CHAPTER III

CHAPTER IV

Comments on the Draft EIR and Responses to Comments

Subject: Lawrence Berkeley National Laboratory 2006 Long Range
Development Plan & Draft Environmental Impact Report

LBNL 2006 Long Range Development Plan . 201074
Figure III-3
 LRDP Land Use Map

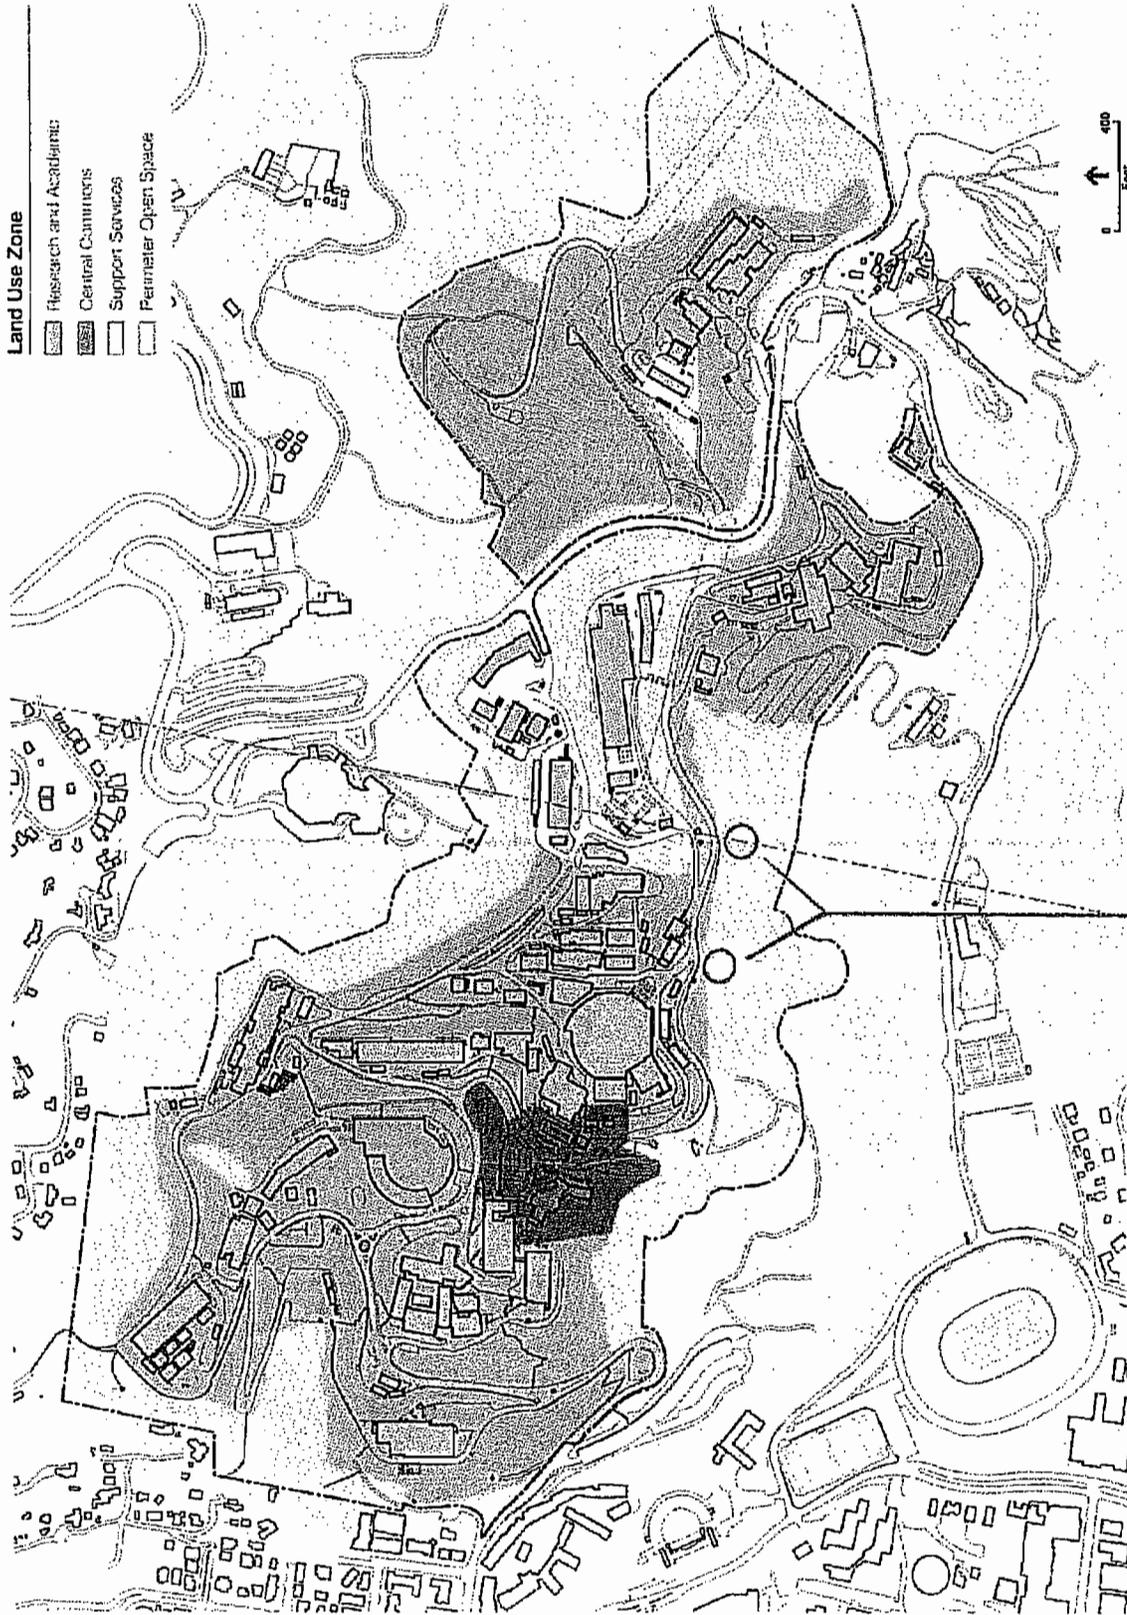
EBMUD is in the process of planning a new storage tank located at the LBNL/UC Campus border. We have annotated the Draft EIR Figure III-3 with the tank location alternatives. The final decision and associated environmental documentation (likely a Mitigated Negative Declaration) will be completed by mid 2008. Construction of the tank and the inlet/outlet pipeline is currently scheduled for 2010 through 2011. Please include reference to this important EBMUD water system improvement in your EIR process.

This proposal is conceptually incorporated into the Final EIR by virtue of its inclusion in the comment letter. No textual revision to the DEIR is necessary. The specific CEQA analysis related to a forthcoming proposal for this project will need to follow when that information becomes available, including size, location, and timing of such a project. LBNL looks forward to working with EBMUD as planning for this proposed project develops. It is not expected at this time, however, given what is available about this proposal, that addition of a single storage tank would result in any substantially greater impacts related to construction. Berkeley Lab understands that this proposed tank would serve areas downslope of the Lab's hill site, and that it may require some discretionary approval from the University of California.

Figure 2. Groundwater Contamination Plumes, Third Quarter FY03.

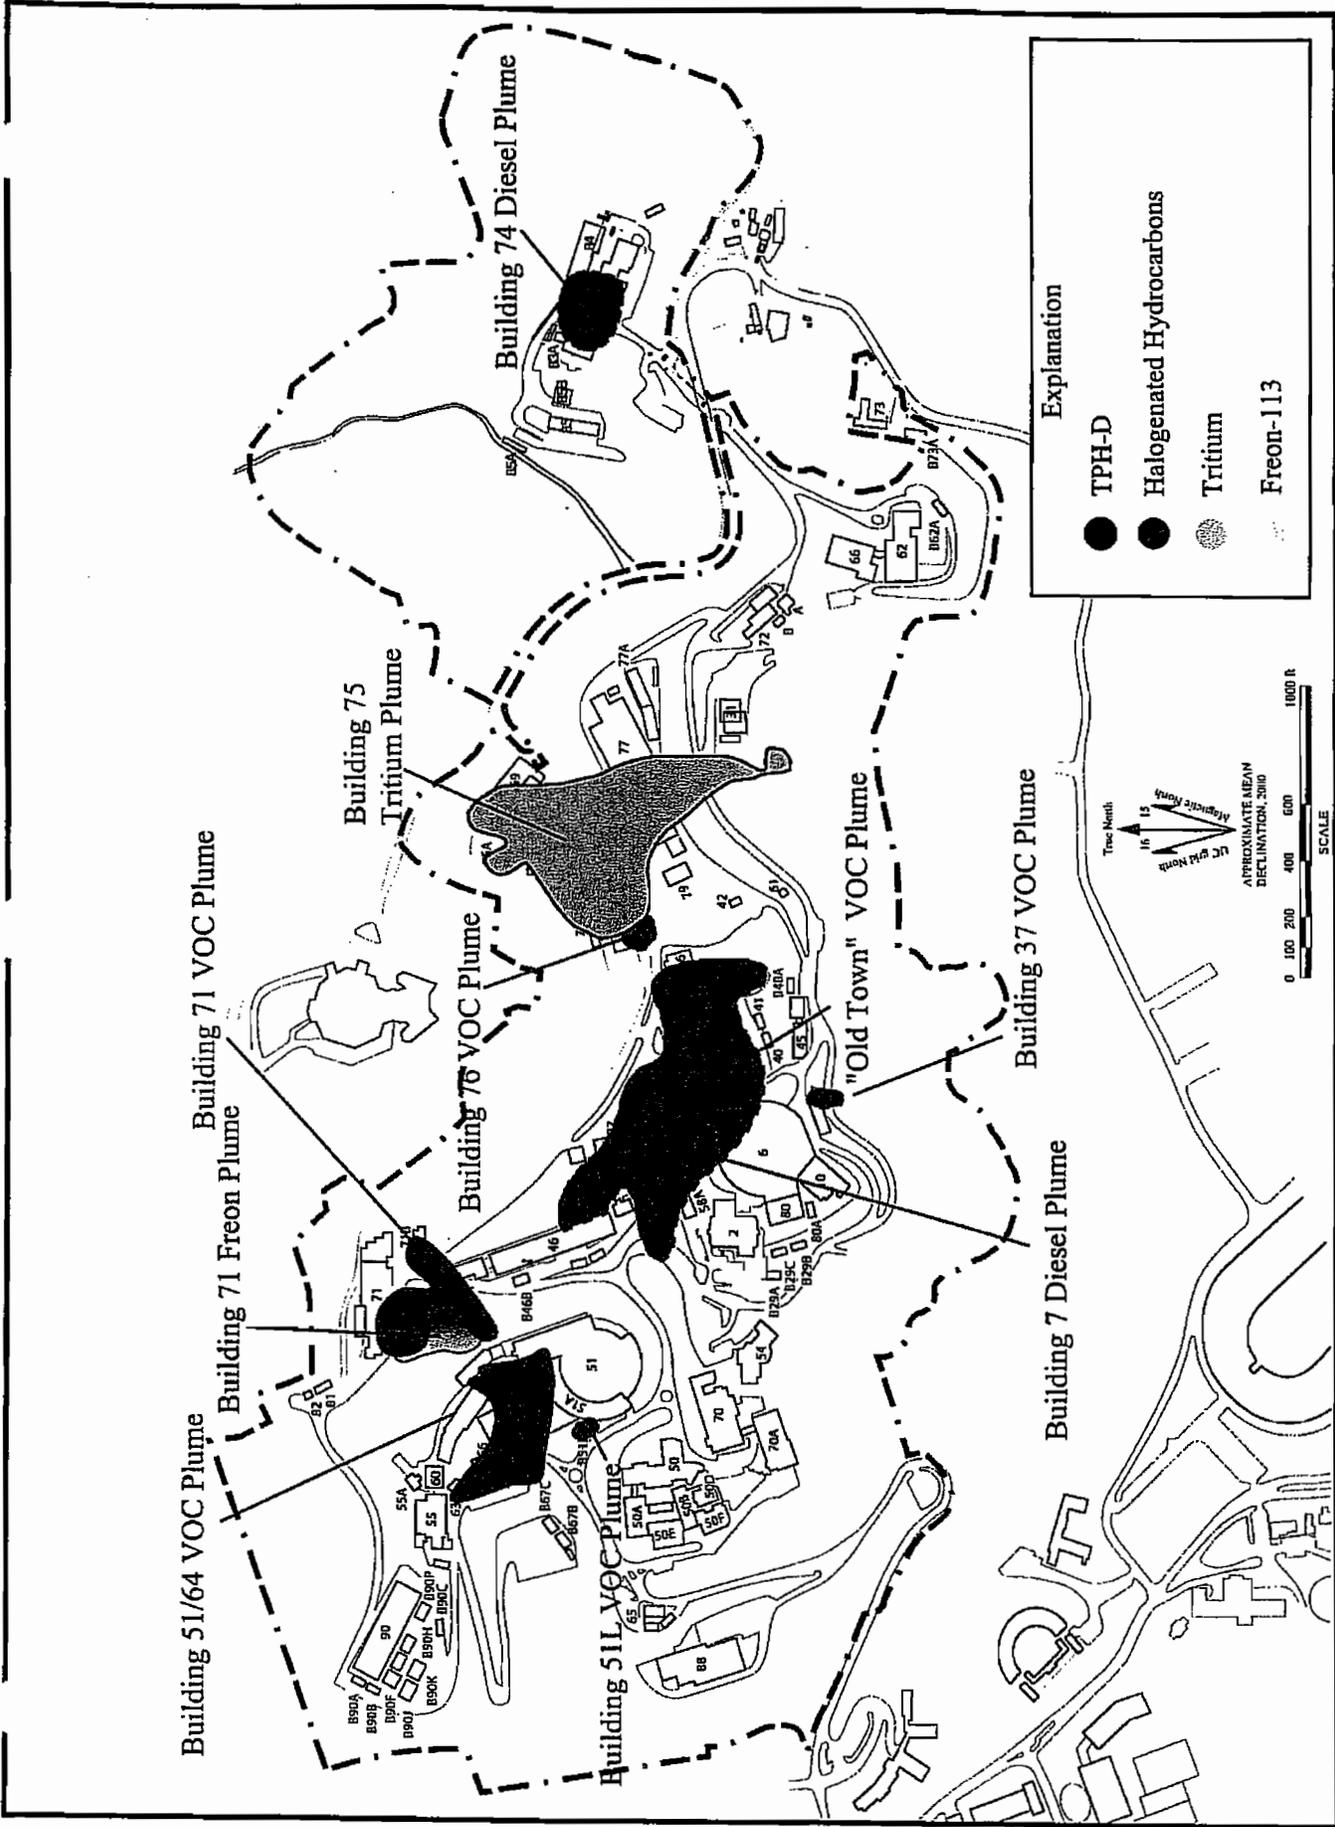
The DEIR fails to assess in detail any of the above referenced natural and manmade hazards. In addition, the UC Berkeley's 2020 LRDP referred to the demolition of LBNL buildings 1 and 3, the Donner and Melvin Calvin laboratories located on central UCB Campus. The LBNL DEIR fails to evaluate the Cultural Resources, Hazards and Hazardous Materials, Traffic etc. impacts from the demolition of these two buildings.

FIGURE 3 GROUNDWATER CONTAMINATION PLUMES IN RELATION TO THE MODERN AND HISTORIC DRAINAGE NETWORKS AT LBNL

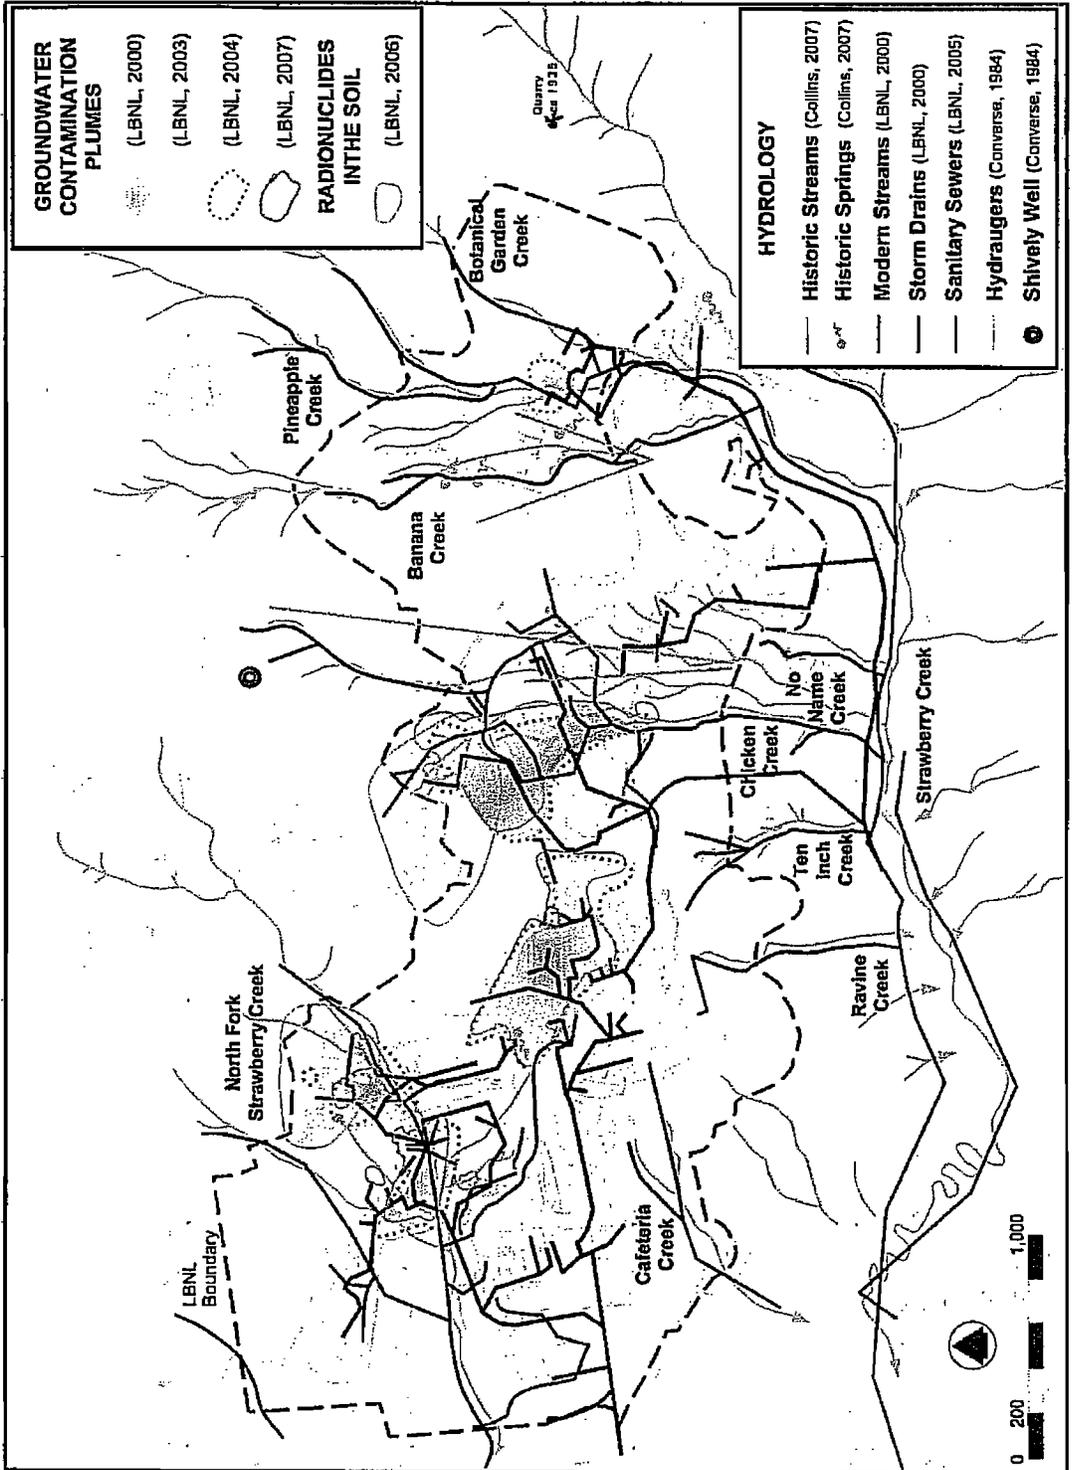
Of special concern is the proposed location of the massive 175,000 sq. ft. CRT Building, right in the middle of the Alquist-Priolo Earthquake Fault Zone (Hayward Fault), clearly defying the very purpose of the Alquist-Priolo Earthquake Fault Zoning Act. In addition the Lab fails to consider the protection of Cafeteria Creek, next to the CRT Building. The DEIR also fails to describe a comprehensive watershed management plan and its implementation for the protection of the many named tributaries of Strawberry Creek. (Figure 3)

Figure 4. Concentrations of Tritium Detected in Surface Water Samples (pCi/L), February 2003.

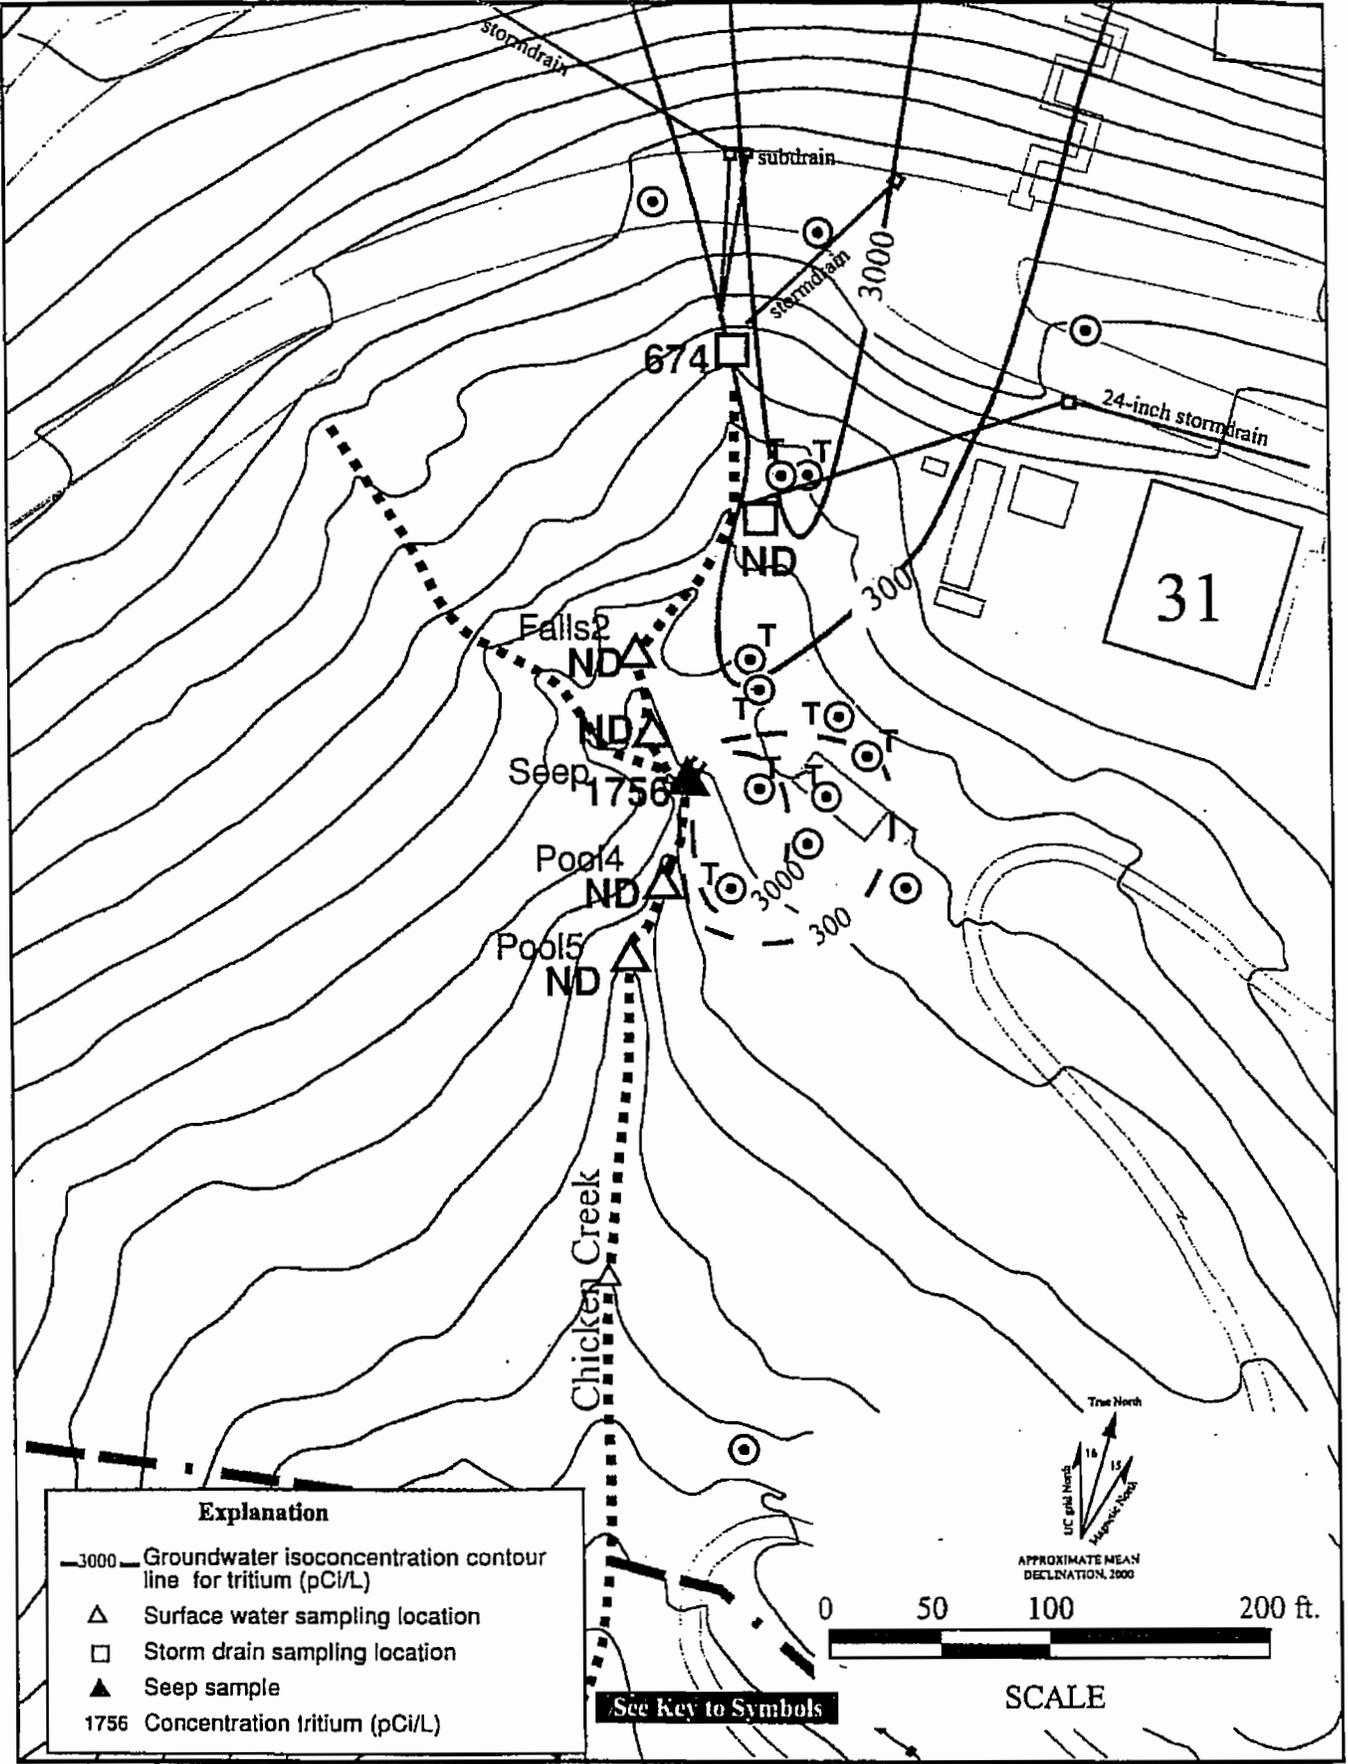
Another hazard location is designated for the British Petroleum funded Biofuels Institute, to be built next to the nanotech facility, Molecular Foundry in the Chicken Creek sub-basin. The area is the location of a large radioactive tritium groundwater plume, where seepage from the groundwater to surface water has been detected. (Figure 4)

FIGURE 7 COMPILATION OF FAULT MAPPING AT LBNL IN EAST CANYON

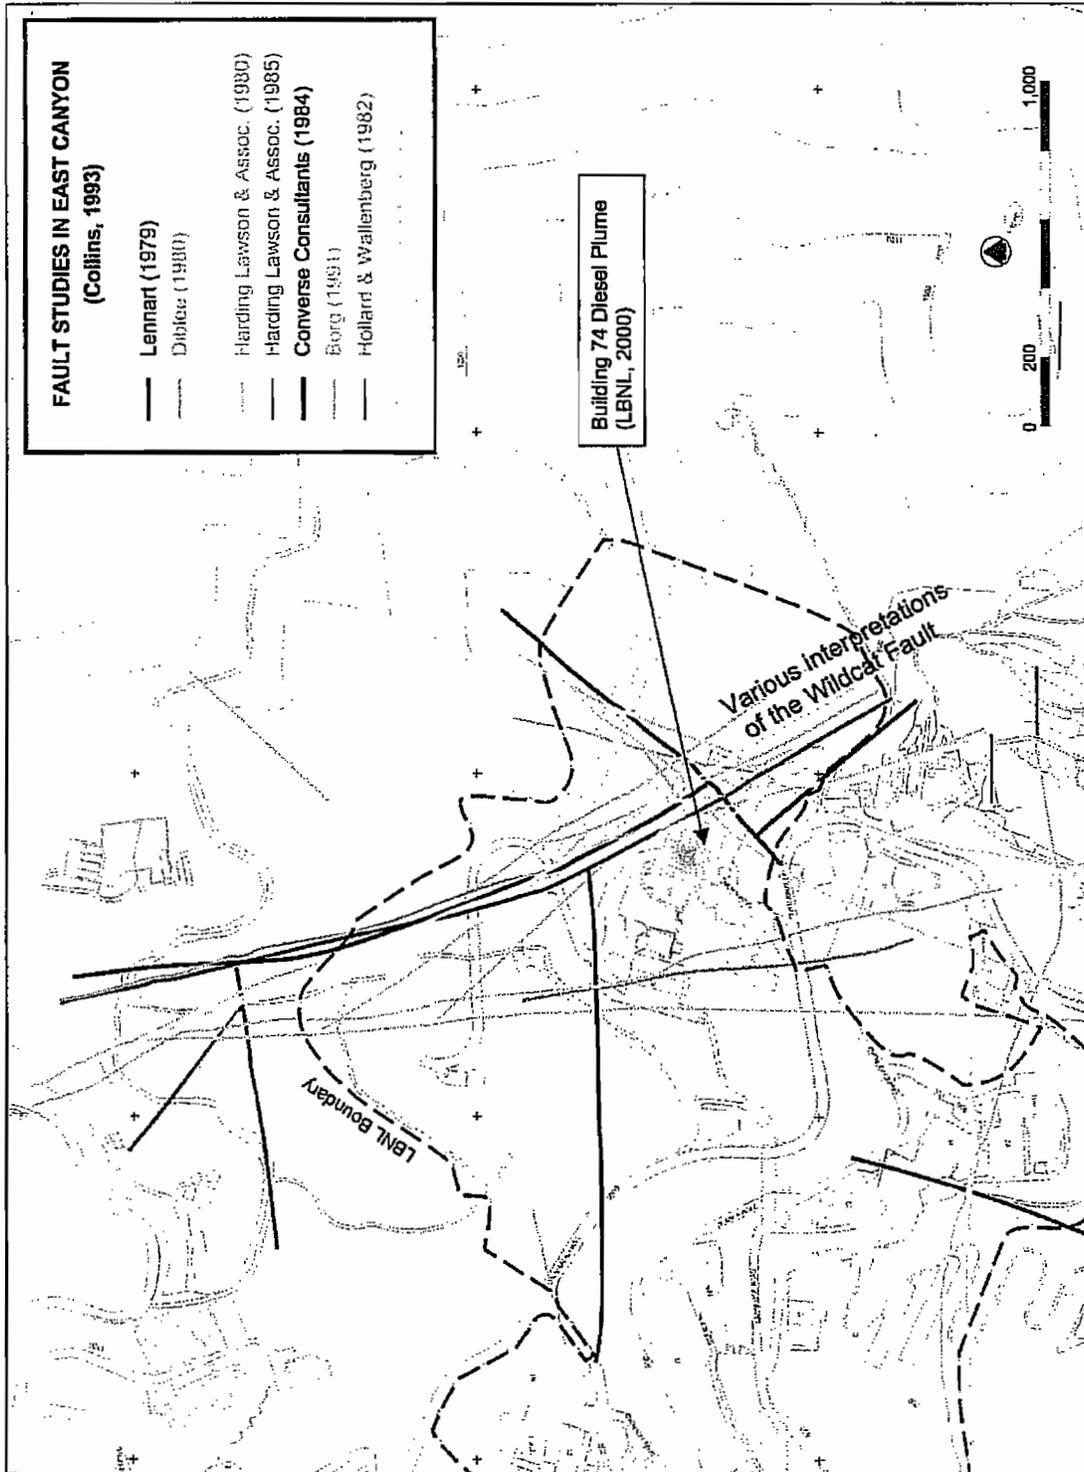
The treacherous East Canyon area has been selected at least for 8 new structures. Figure 7 shows the various interpretations of the location of the Wildcat Fault, within this area of the Lab.
